## DFCM Addendum #1

**Reference:** Zions Building Kitchen Update  
Utah State Fairpark  
DFCM Project #25266370  
U3P Event #DA25040

# ADDENDUM NO. 1

## FAIRPARK ZION'S KITCHEN

A112

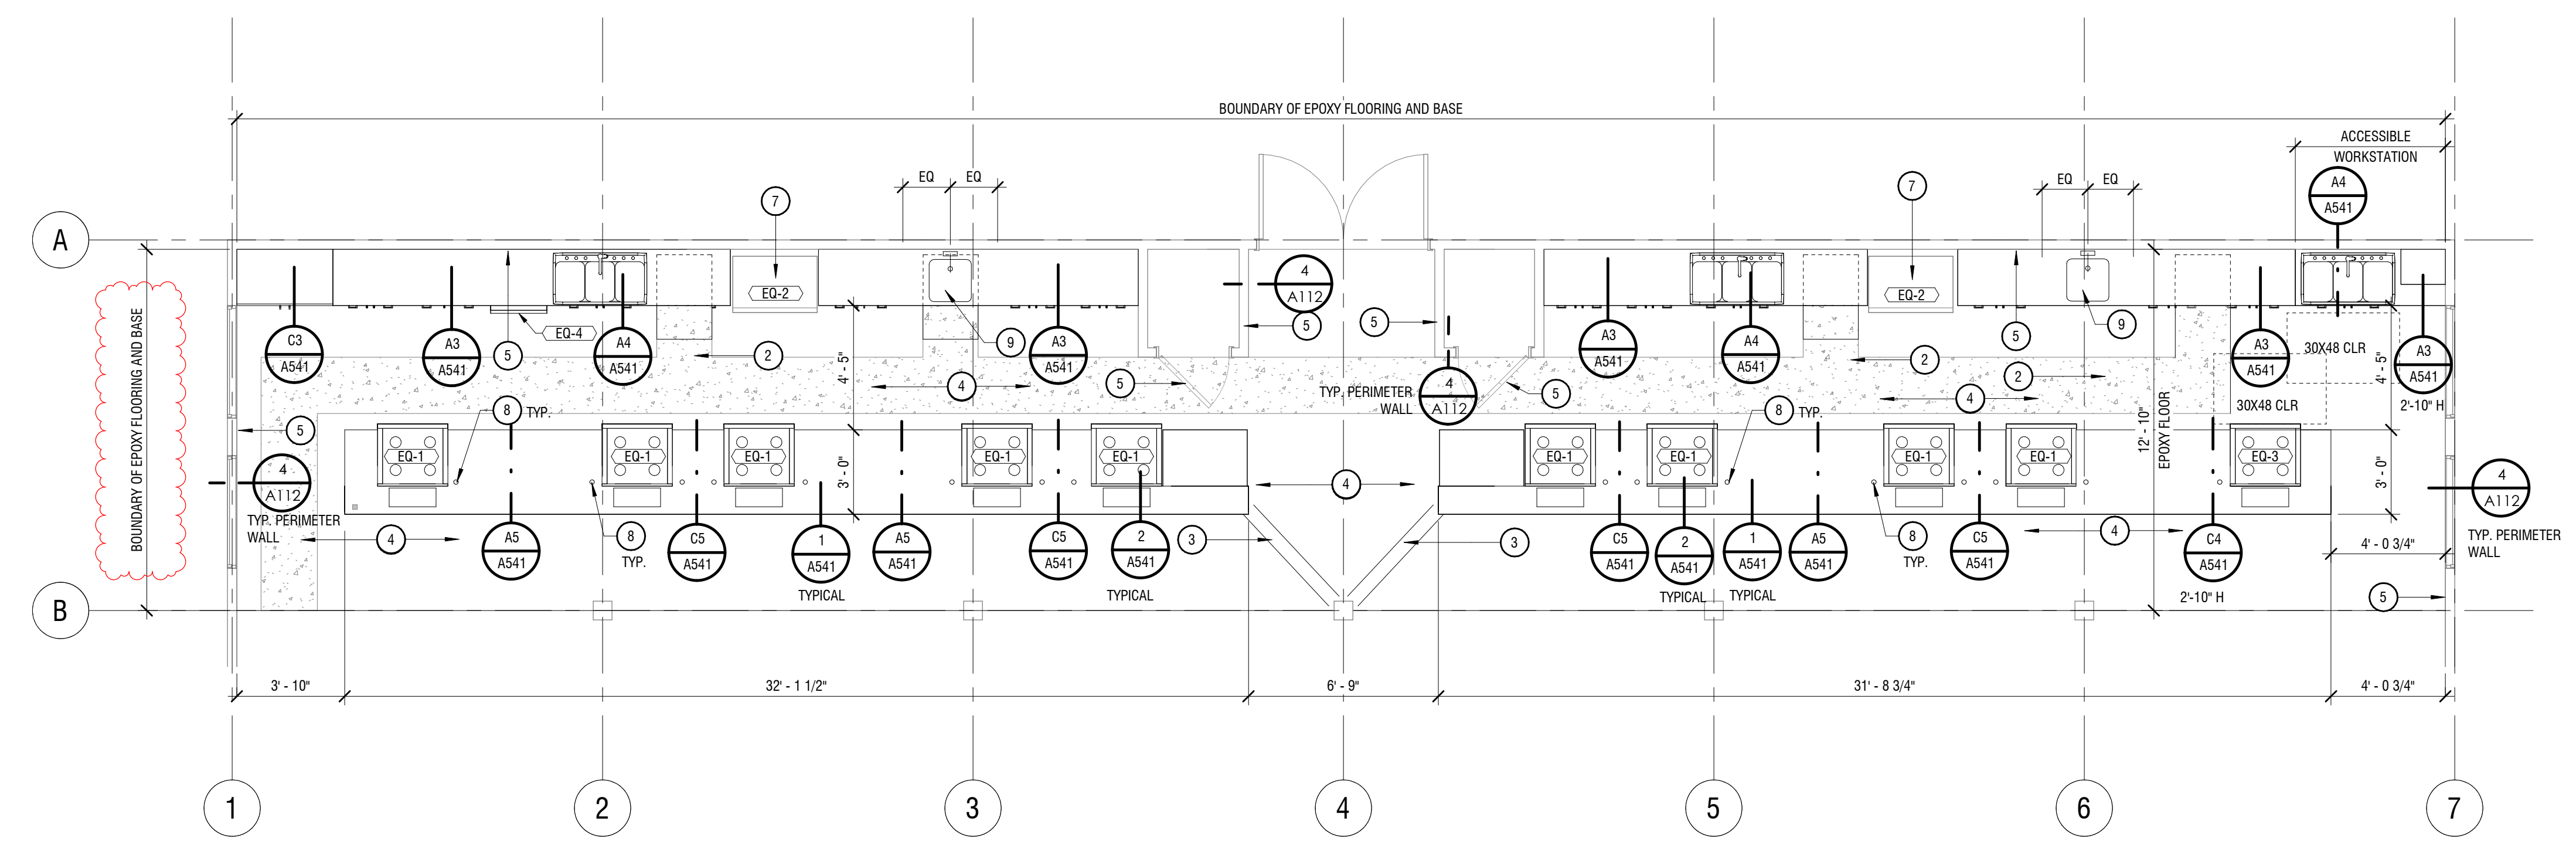
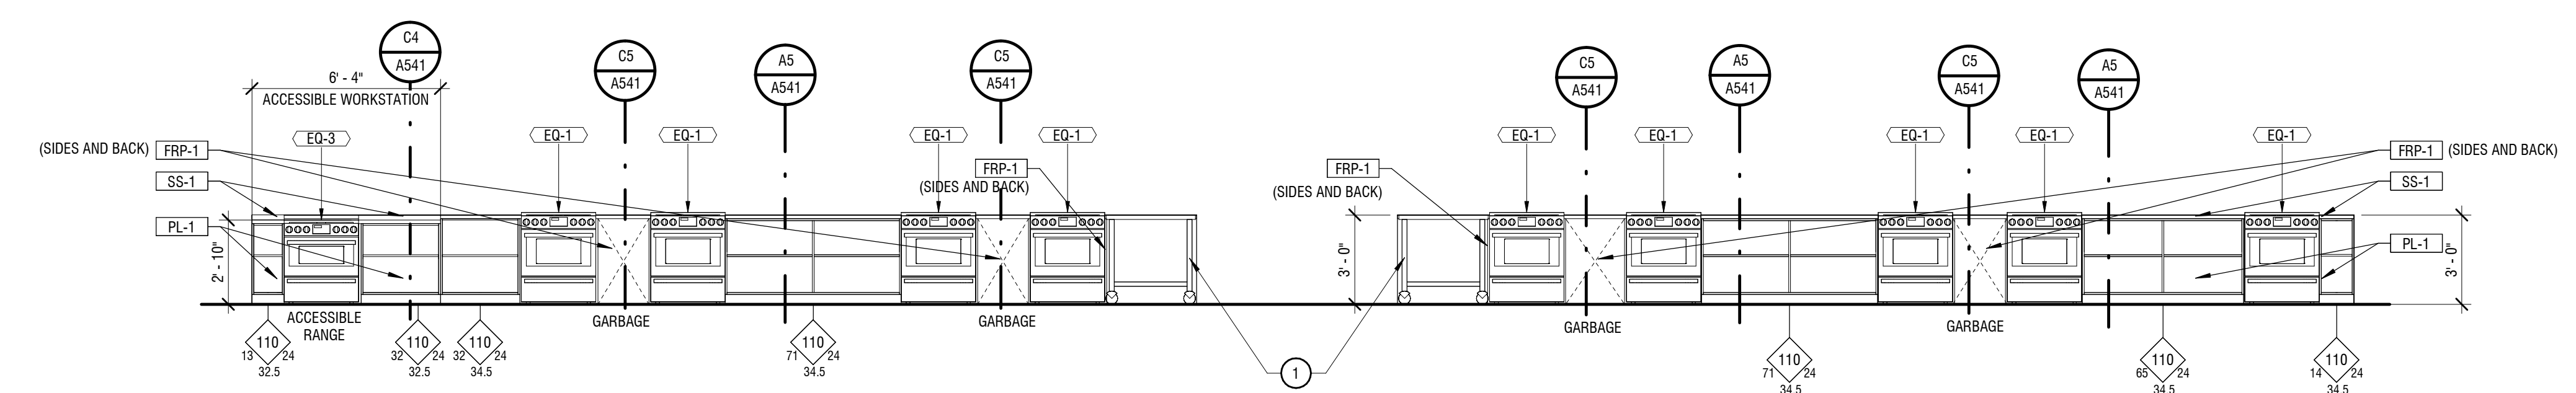
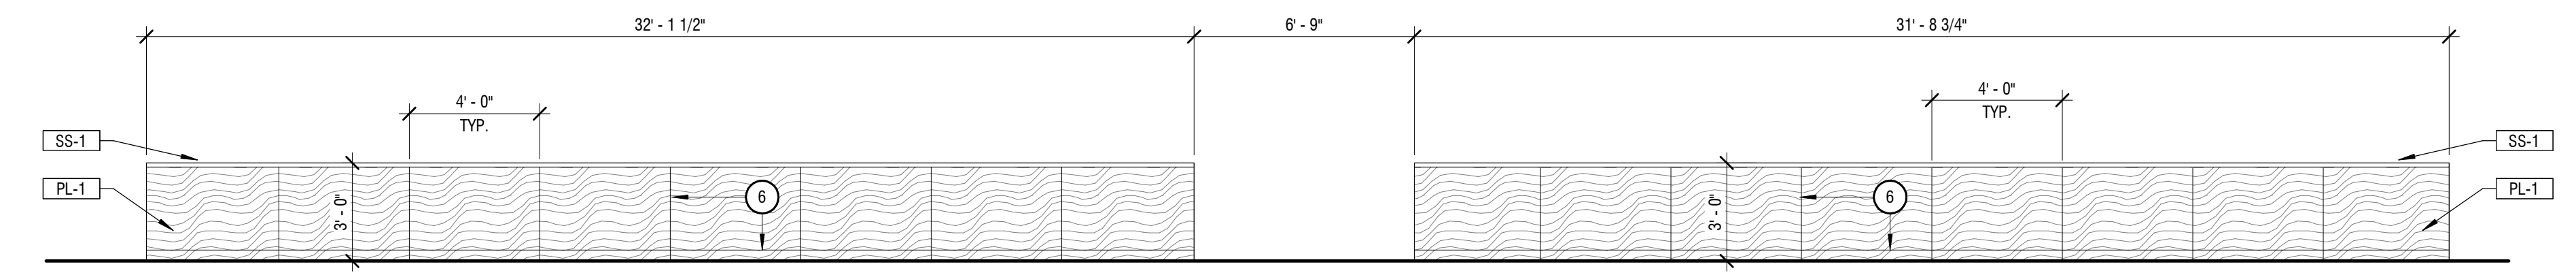
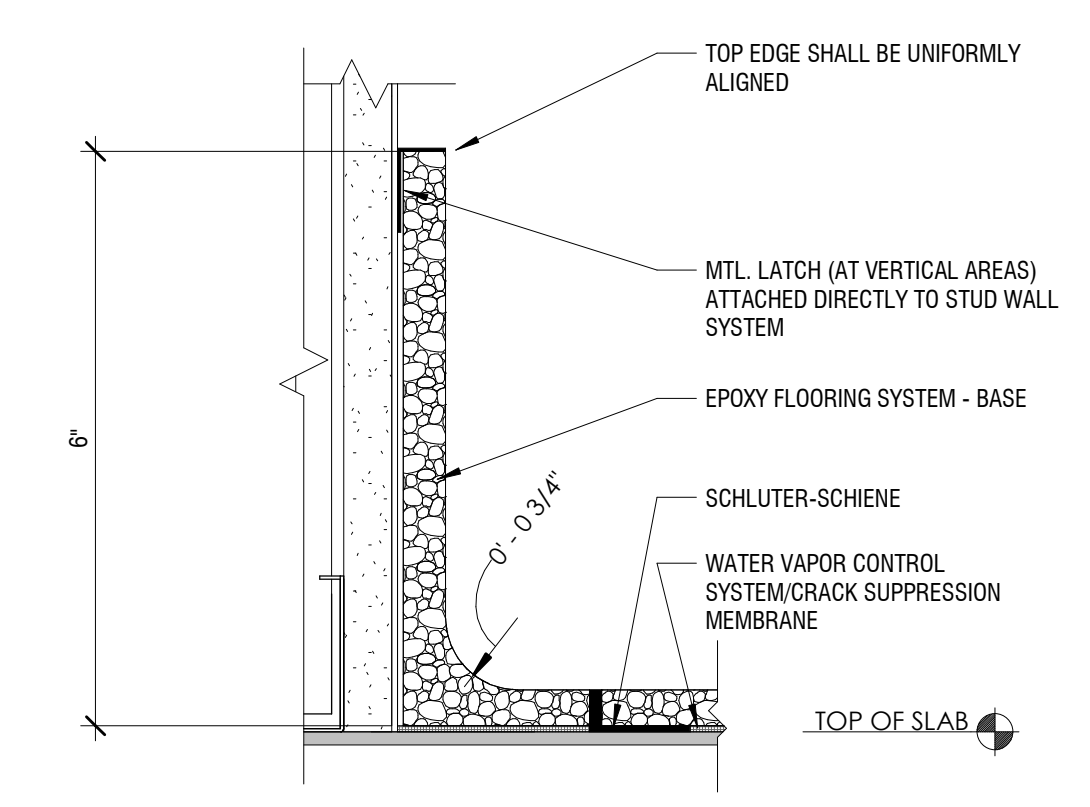
1. Civil
  - a. NA
2. Landscape
  - a. NA
3. Architectural
  - a. AD101 – Remove concrete at existing waste line to expose and replace the existing line.
  - b. A112, see revision adding patch and repair to the concrete floor.
  - c. A112- extend extent of epoxy floor and base to grid line B
  - d. A114 – Add widow shades to the north windows.
4. Structural
  - a. NA
5. Mechanical/Plumbing
  - a. Toilet Rooms – Replace the instantaneous water heaters using the existing location and voltage and phase. Contractor to circuit trace each water heater back to the panel. To establish the voltage and the KW size requirement. The water heater with same make as the kitchen water heaters.
6. Electrical
  - a. EP100 - See narrative attached drawings
  - b. EP101- See narrative and attached drawings
  - c. EP601- See narrative and attached drawings
7. Other
  - a. None

1. Architectural and Plumbing drawings do not match. Sheet A112 shows three locations for slab on grade removal for new sewer line connections to existing sewer line between the cabinets. MP101 shows replacement of the existing sewer line in its entirety with a new 4 inch line and connection to existing at gridline B [Keyed Note P7]. Which is correct?

LOCATIONS WHERE THE EXISTING FLOOR WILL NEED TO BE REPLACED TO ACCOMMODATE THE NEW PLUMBING LINES.

Response: Sheet MP101 is correct. Sheet A112 revised to Match sheet MP101.

AD101

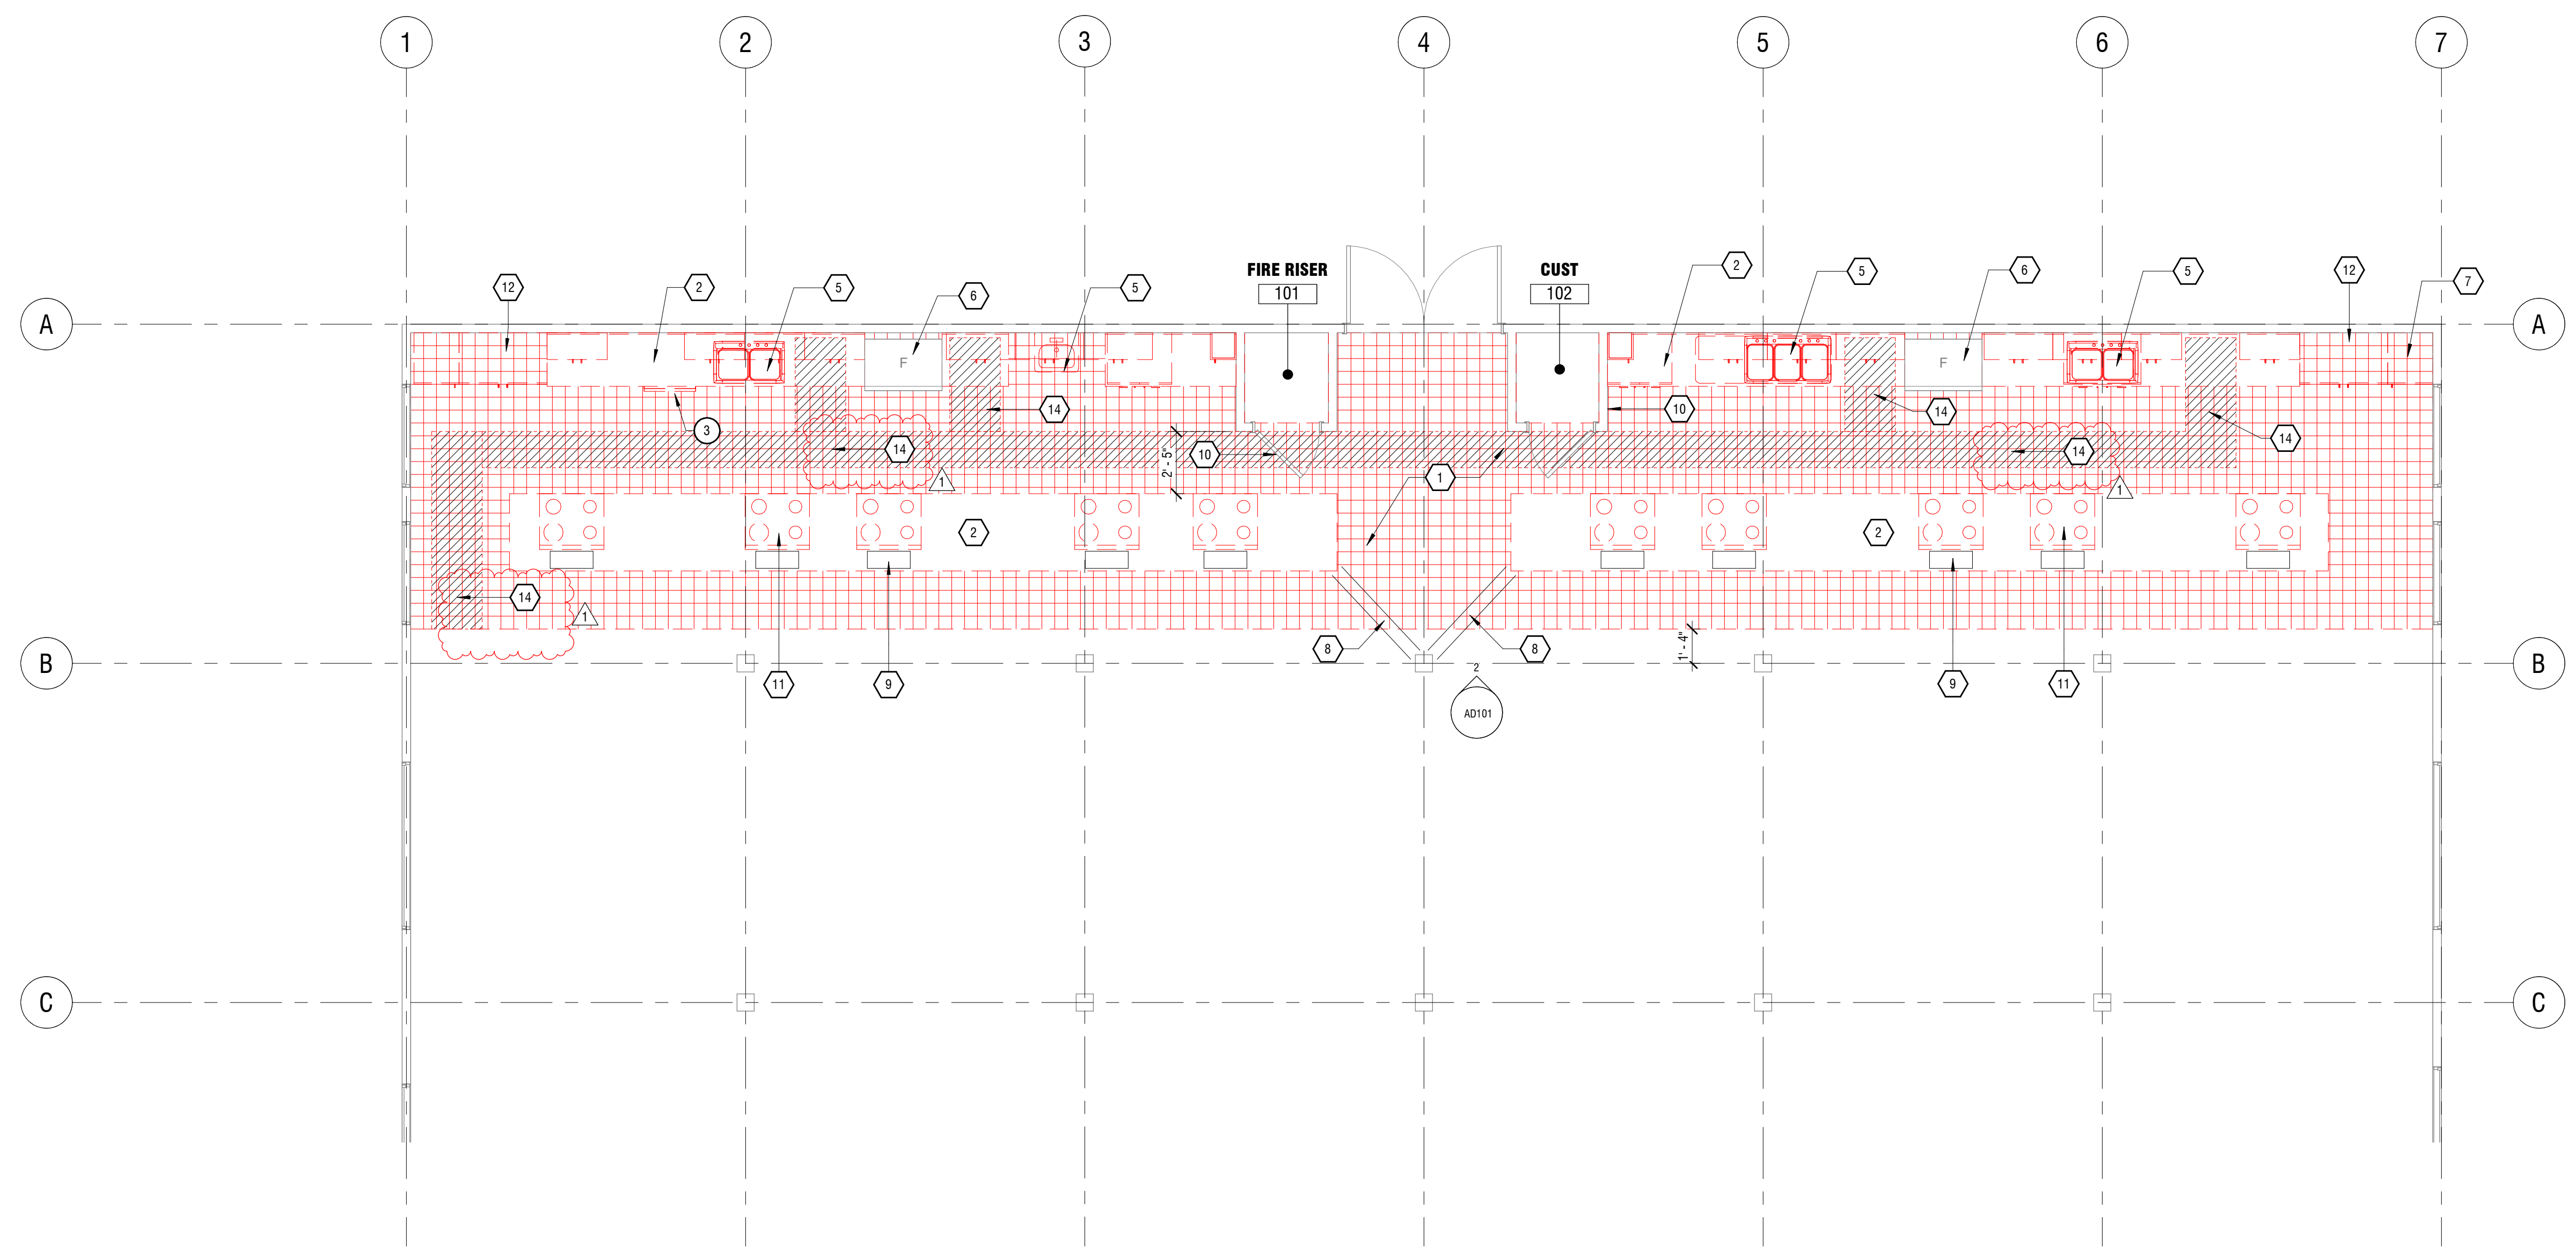
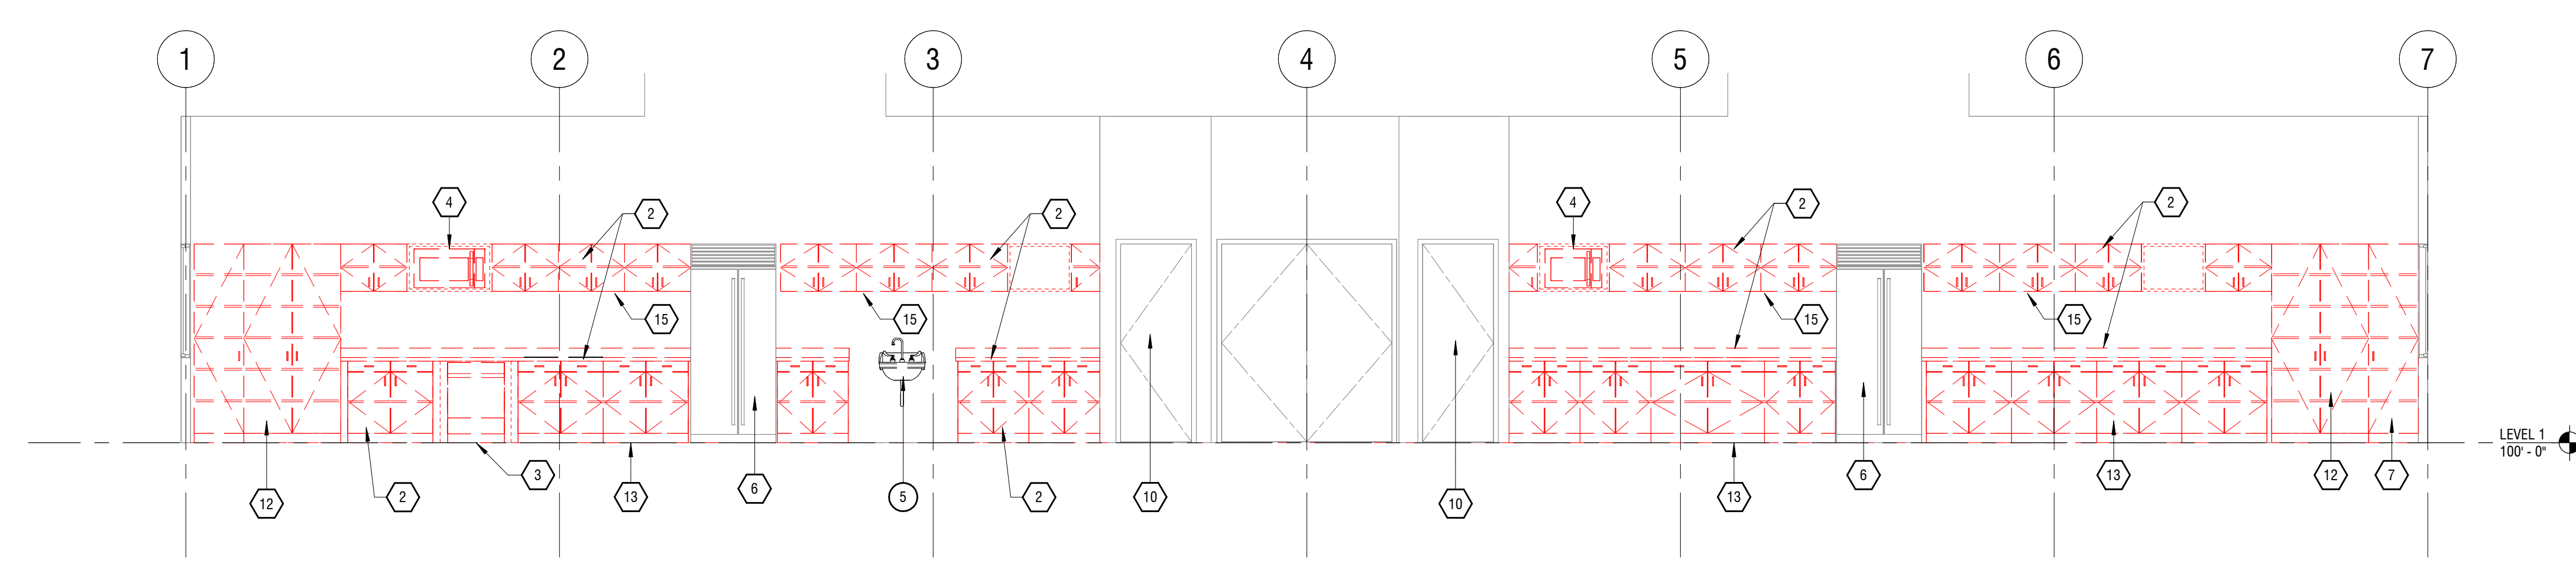
- REMOVE EXISTING CONCRETE FLOOR, EXPOSE EXISTING WASTE LINE IN PREPARATION OF NEW GREASE TRAP INSTALLATION
- REMOVE UNDER CABINET LIGHT FIXTURES. PROTECT, SAVE AND RETURN THE TO OWNER.
